NISQUALLY INDIAN TRIBE
Tribal Historic Preservation Office

4820 She-Nah-Num Drive S.E.
Olympia, Washington 98513
360.456.5221 (main)
877.768.8886 (toll free)
www.nisqually-nsn.gov

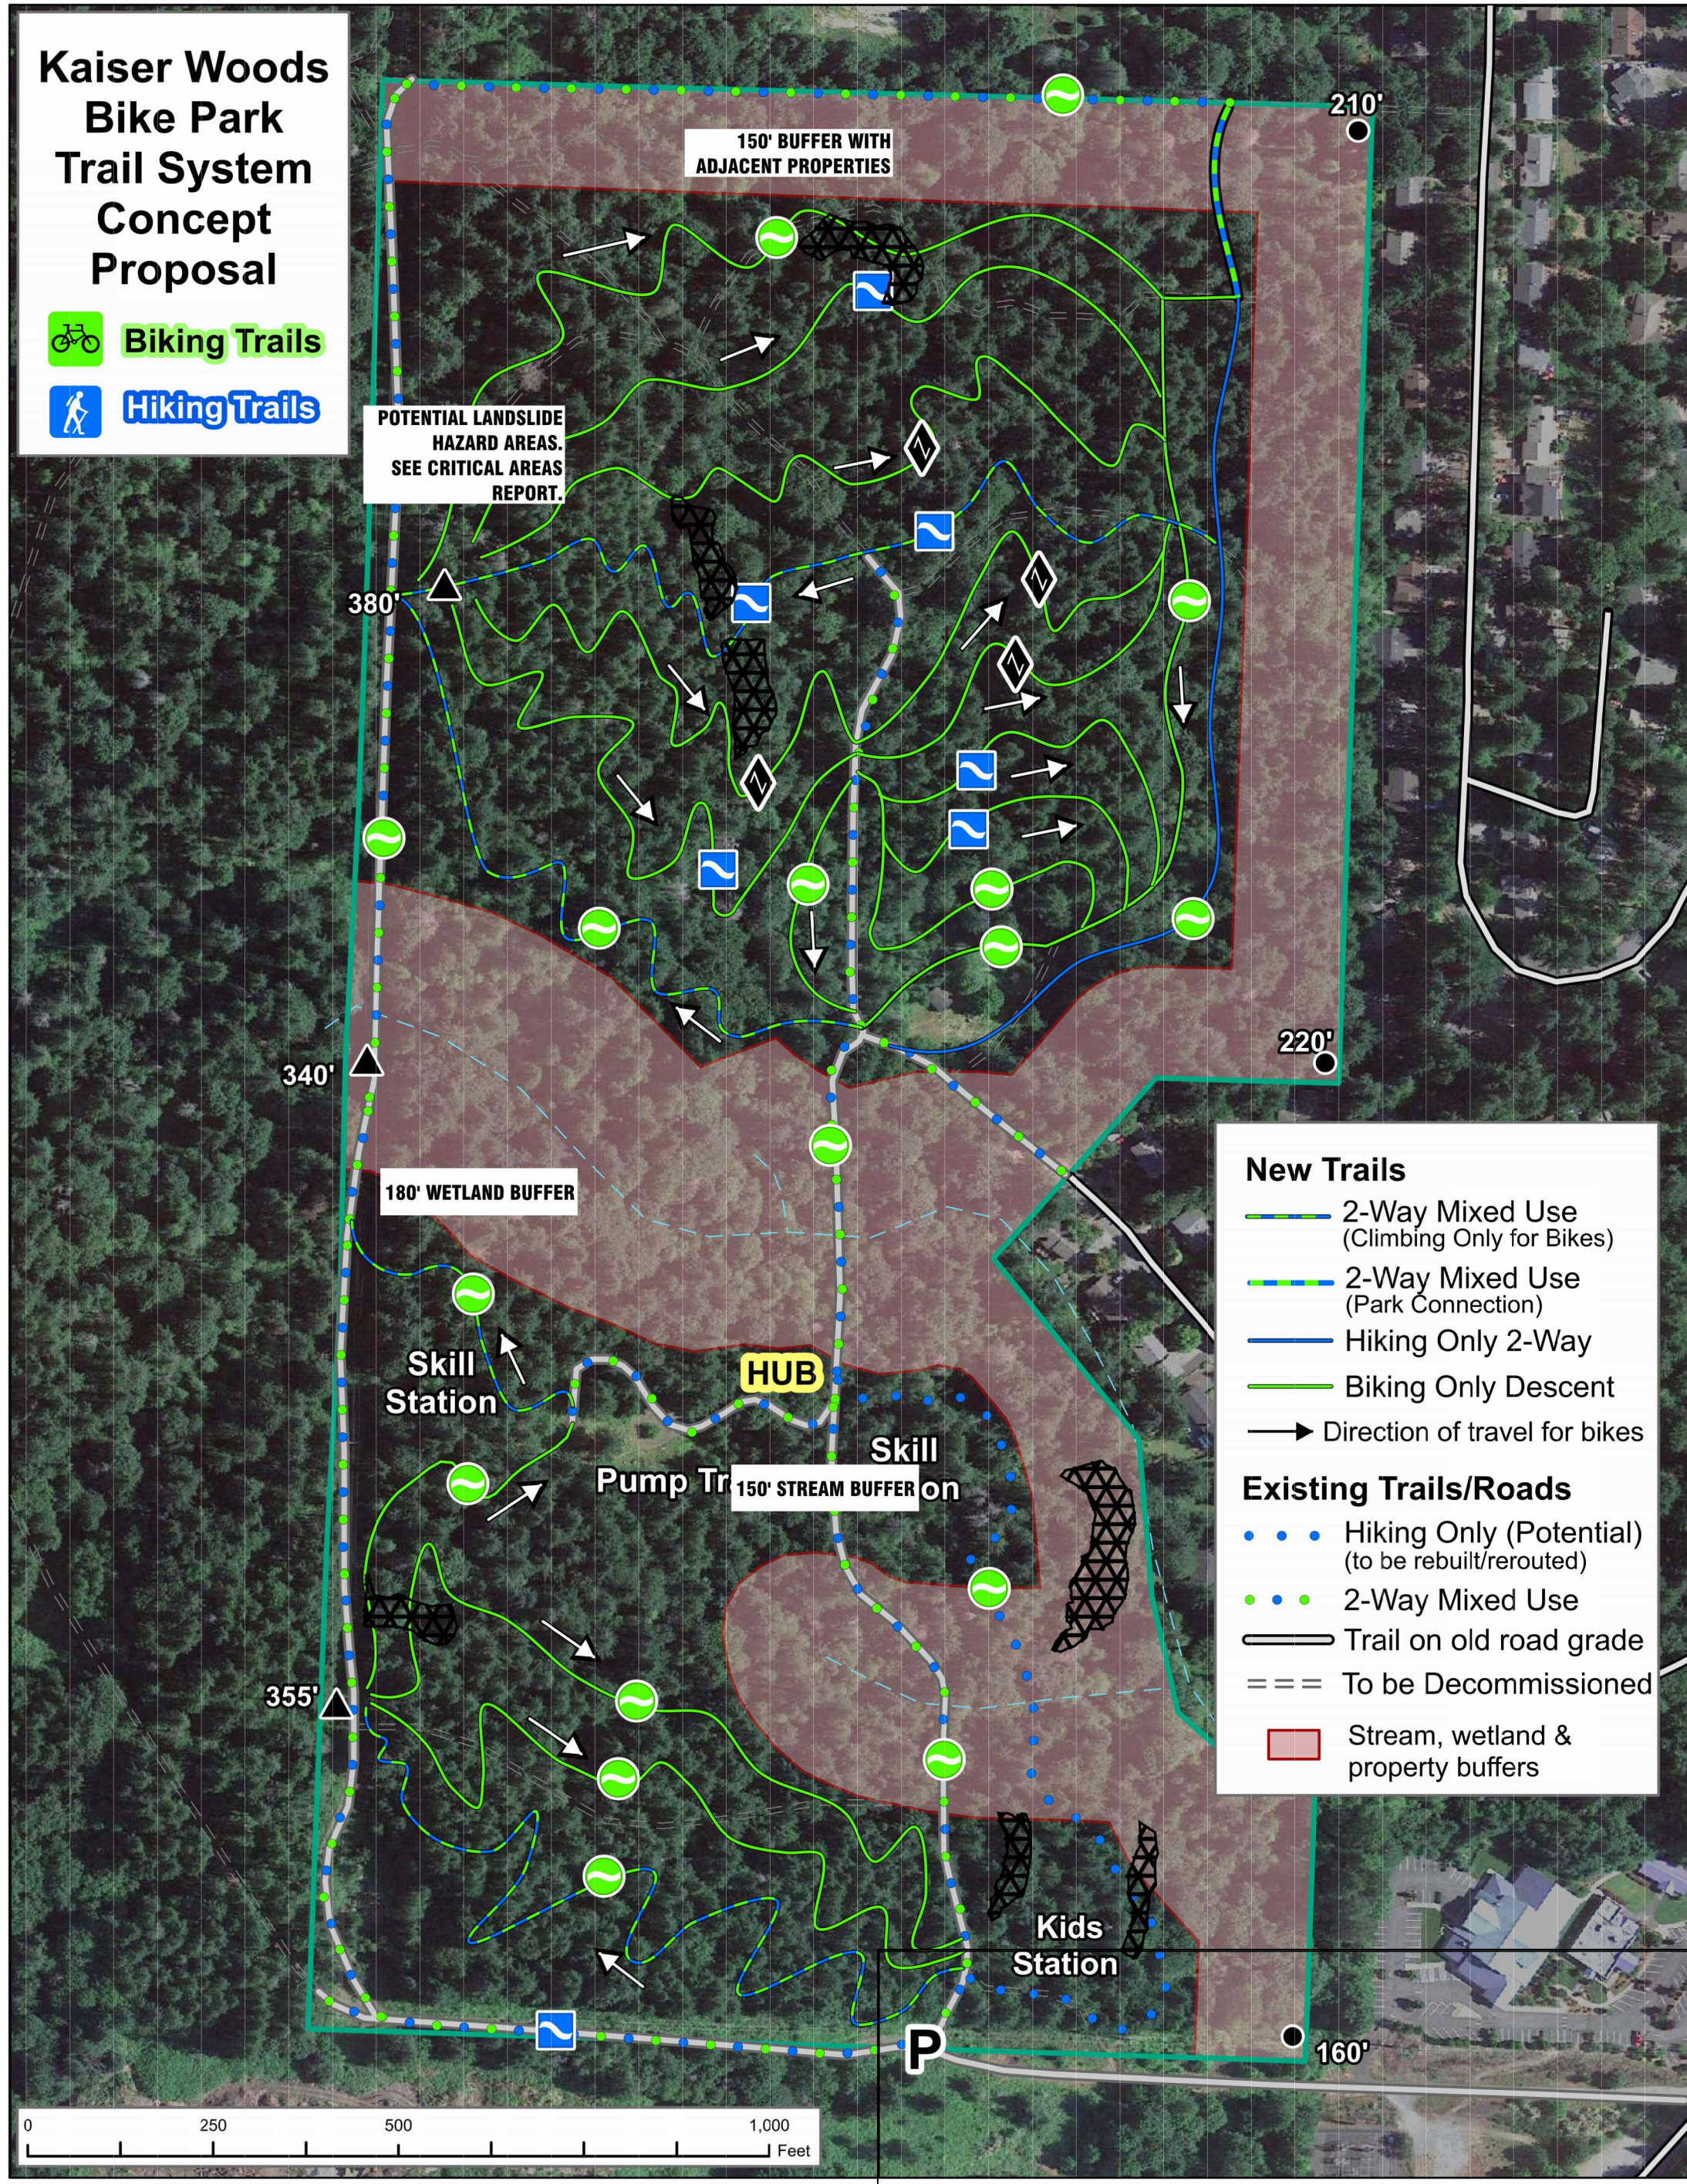
NO.	DATE	REVISION	REVISION PER CIPRO SUBSTANTIVE REVIEW COMMENTS
1	11/26/2024		REVISED PER CIPRO SUBSTANTIVE REVIEW COMMENTS

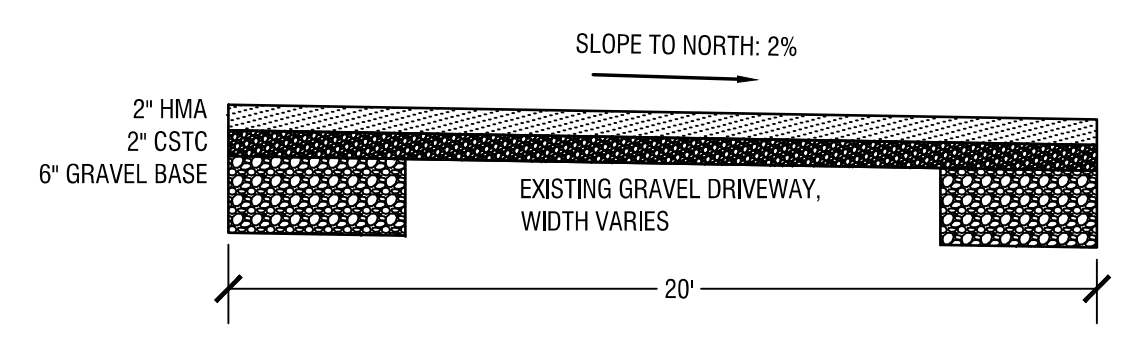
NO.	DATE	REVISION	REVISION PER CP&D SUBSTANTIVE REVIEW COMMENTS
1	11/26/2024
